Docket Number:	19-SPPE-03
Project Title:	Sequoia Data Center
TN #:	231335
Document Title:	Record of Conversation
Description:	This document was docketed for Laurelwood Data Center and is needed for the Sequoia Data Center Project
Filer:	Susan Fleming
Organization:	Energy Commission
Submitter Role:	Public Agency
Submission Date:	12/30/2019 8:32:58 AM
Docketed Date:	12/30/2019

CALIFORNIA ENERGY COMMISSION
REPORT OF CONVERSATION Page 1 of 1

PROJECT TITLE: Laurelwood Data Center **Docket:** 19-SPPE-01

SUBJECT: Siliocon Valley Power (SVP) Responses to Questions from Staff

SVP Transmission Overview

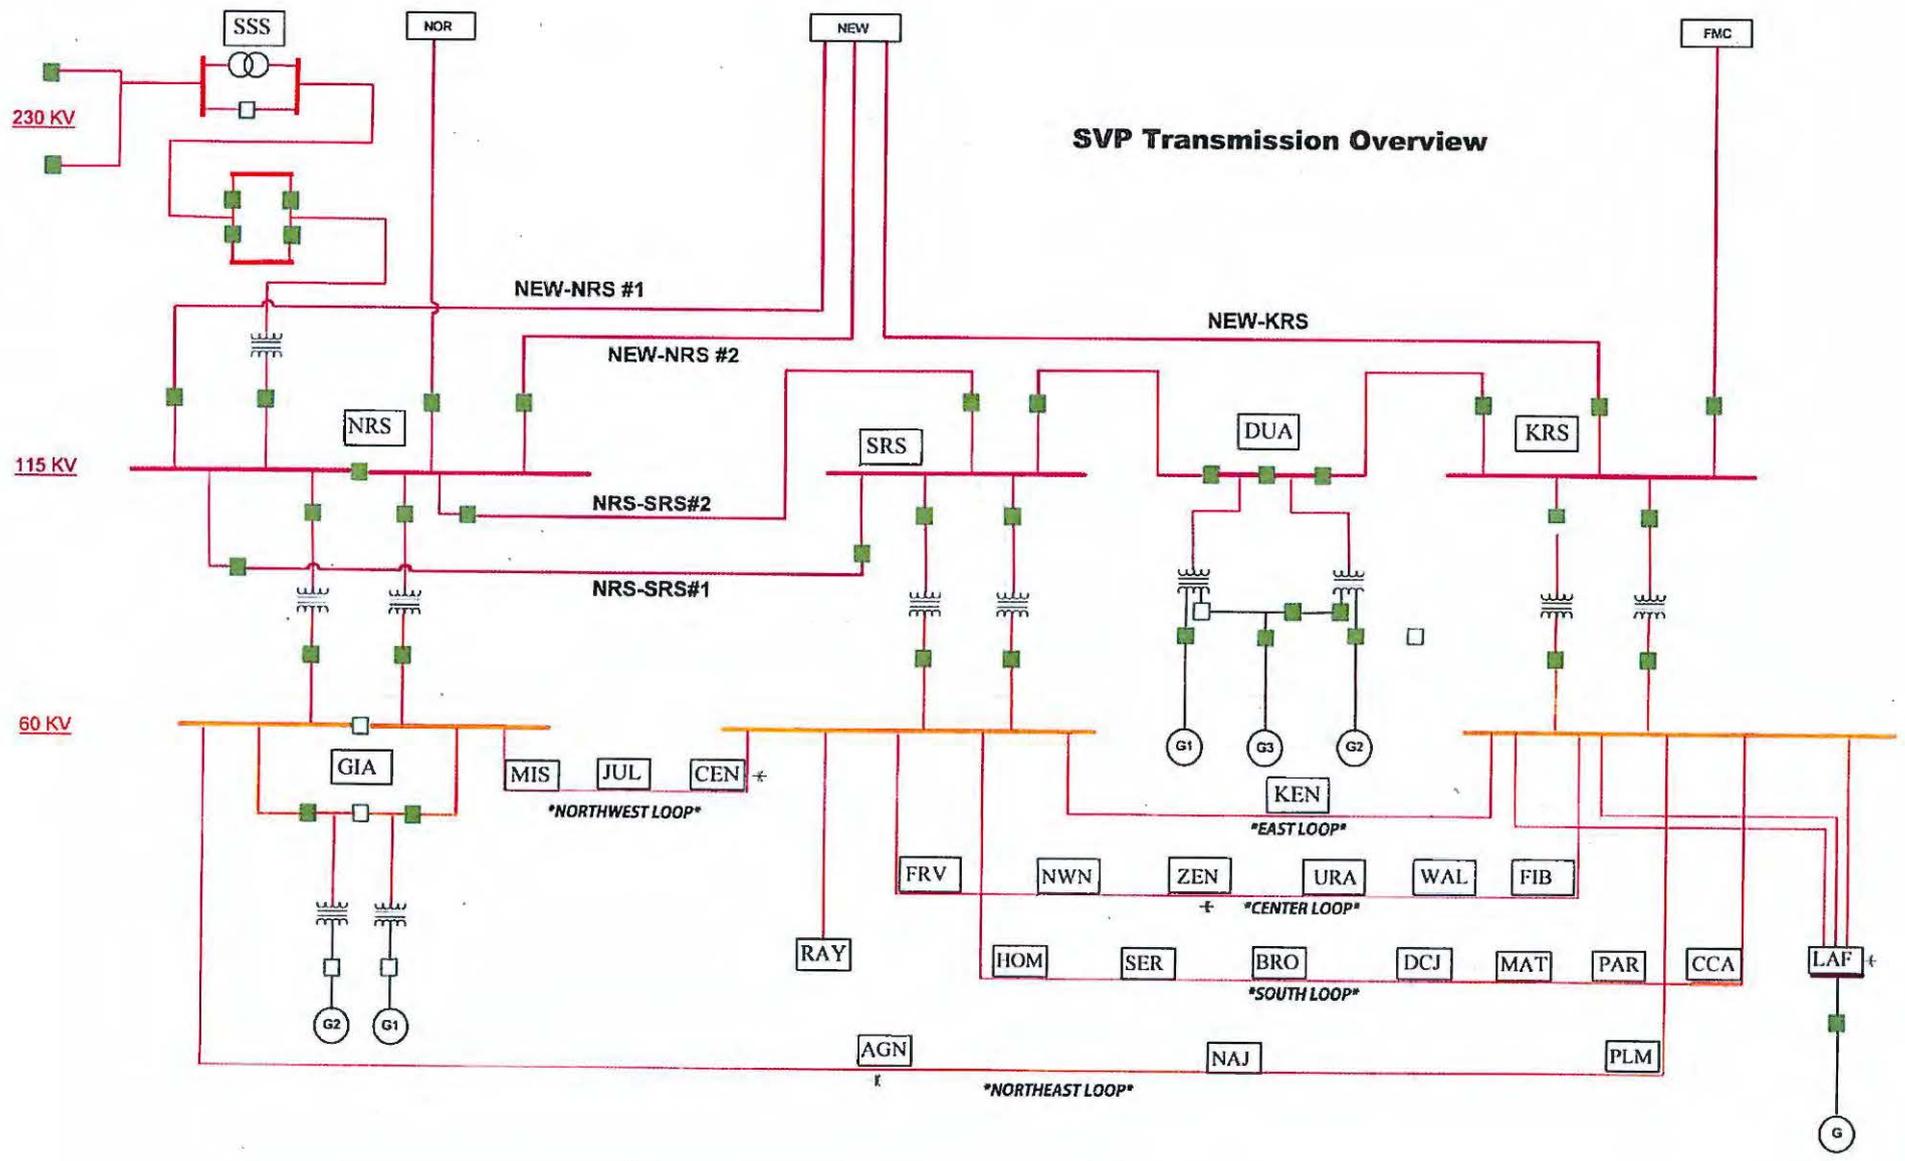
2. Please provide a description of the SVP system in general and the other 60 kV loops that would serve data centers.
 - a. Could you provide a one-line diagram and a ".shp" file of the 60 kV and above lines serving the Silicon Valley Power System? Would you have any concerns with us using either of these in a public document?

See attached SVP Network Diagram 8-2-19.

See Attached Diagram SVP CA Energy Map 8-2-19 and the SVP Network Diagram
